DEVELOPMENT REVIEW BOARD - **HYDROLOGY SECTION**

DRB Project Number: 2021-006297 Hearing Date: **5-11-2022**

Project: Tracts 469 & 470 Lands of Atrisco Land Grant-7300 Santa Barbara Agenda Item No: **12**

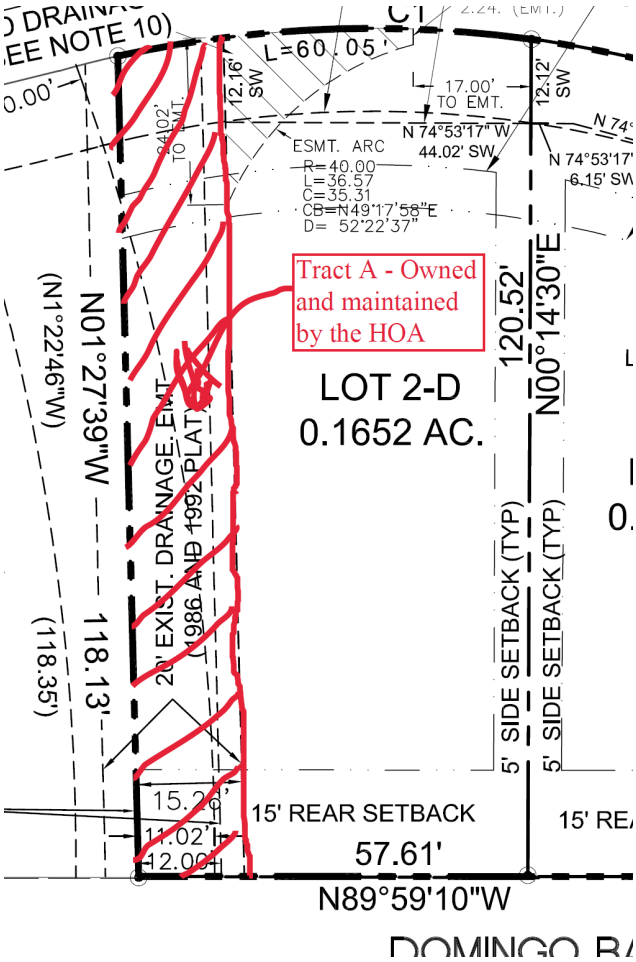
- Hydrology sent a comment letter (D19D001F) on May 09, 2022.
- The existing drainage easement shown as part of Lot 2-D should be on its own tract to be owned and maintained by the HOA.

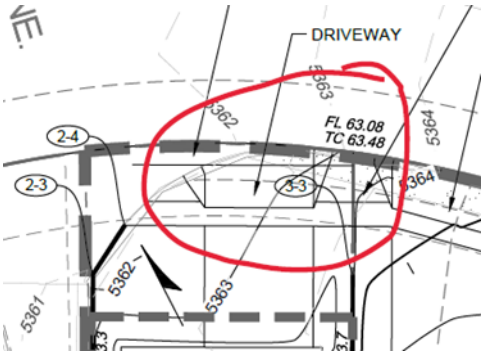
- Typically, the drive pad cannot be built on a radius. Please consult Transportation Section.

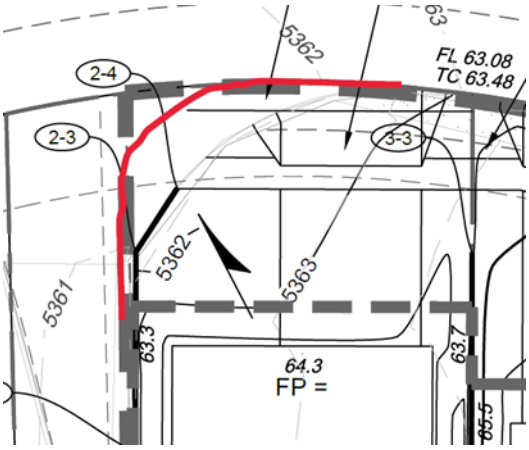
This problem can be solved with extending the curb & gutter along the property line and then have a smaller radius after the drive pad as shown below.

Then the Drainage Easement on the Plat can be reduced.
